# DISCRETIONARY REVIEW ABBREVIATED ANALYSIS

**Record No.:** 2019-013412 DRP  
**Project Address:** 146 Jordan Avenue  
**Permit Applications:** 2019.1127.8326  
**Zoning:** RH-1(D) - [Residential House - One Family- Detached]  
40-X Height and Bulk District  
**Block/Lot:** 1063 / 037  
**Project Sponsor:** Jeffrey Eade  
407 Crestmont Drive  
San Francisco, CA 94131  
**Staff Contact:** David Winslow – (628) 652-7335  
[david.winslow@sfgov.org](mailto:david.winslow@sfgov.org)

**Recommendation:** Take DR and Approve

**03 SECTION AT PROPERTY LINE FENCE**  
 T4 SCALE: 1/2"=1'-0"

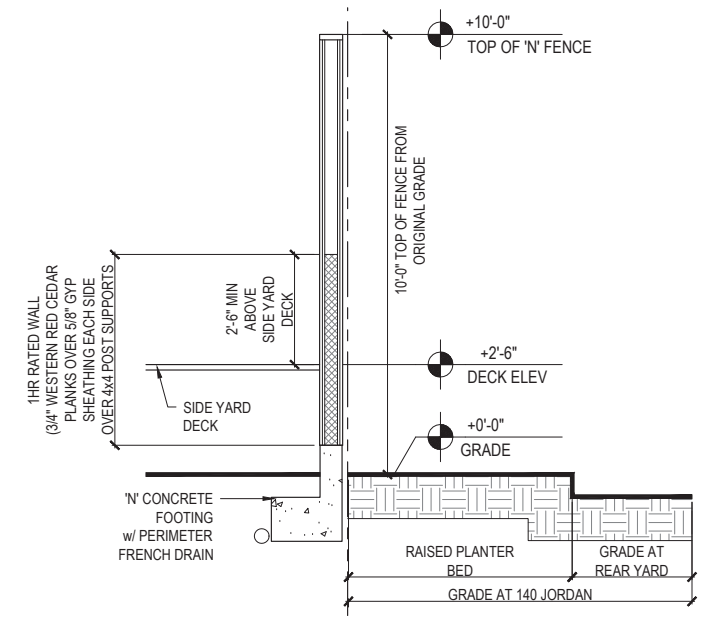
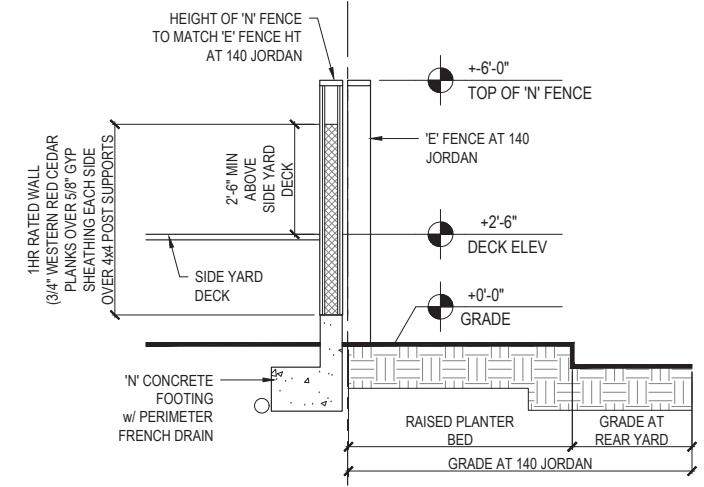
1. The proposed 10-foot high fence will impede light to rear yard and box in from enjoying mid-block open space.
2. Plans do not adequately address drainage and water runoff onto 140 Jordan from previously performed work

1. Return grade level to existing height and maintain fence height of 6’.
2. Install proper drainage systems to address runoff.

Per that Planning Code grade may be increased up to 3’ above the existing elevation and retaining walls and fences in the rear yard are allowed to be up to 10 feet in height from existing grade. However, the proposed design has been modified to address the concerns of the DR requestor with the following modifications:

1. The proposed fence is six-foot above existing grade
2. Although it is not the purview of the Planning Department, the revised plans now include a design to address drainage with the detailed drawings.
